## K157. A ROLLING CODE 2-CHANNEL UHF REMOTE CONTROL

**TRACK ERROR.** Now I made a **track error** when making these PCBs which, strangely, the prototype did not pick up. It is only when you try to add more than one TX units to the RX that the error shows up and does not allow you to do so. I do try to make error-free PCB's but .... I have connected each track to the tact switch to itself inside the tact switch. That is, pin 7 of the RX module is shorted to ground permanently inside the tact switch. I mis-identified which pair of legs were internally connected together; an embarrassing mistake.

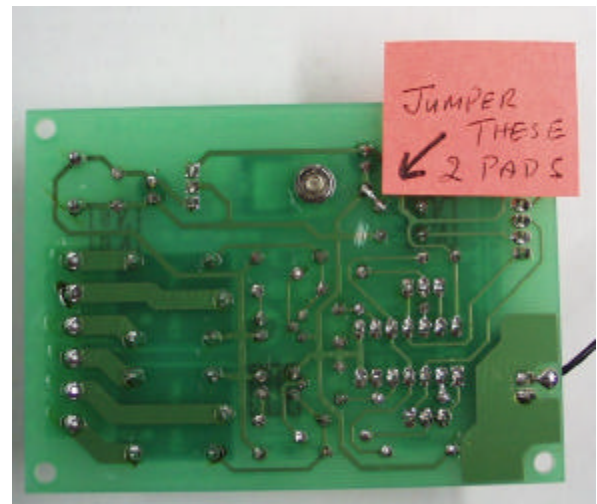
Please cut one track as shown in the photo below and then jumper a leg from the tact switch 0.2" / 5mm to a pad next to it as shown in the photo. Then all is OK. Use an offcut from a resistor leg. This modification should not cause you any problem once you understand the error and look at the photos.

As mentioned there is a track to cut and link to make. Cut the track going to the zippy switch as indicated in the photo.

Then use an offcut from a resistor leg to jumper across two pads as shown in the other photo. Now when the tact switch is pressed pin 7 of the RX module will go to ground and **LEARN**ing of additional TX units will occur.

You can see the cut track.

Connect the other side of the tact switch to ground as shown. Use an offcut from resistor leg. See it at <http://www.kitsrus.com/jpg/k157jump.jpg>
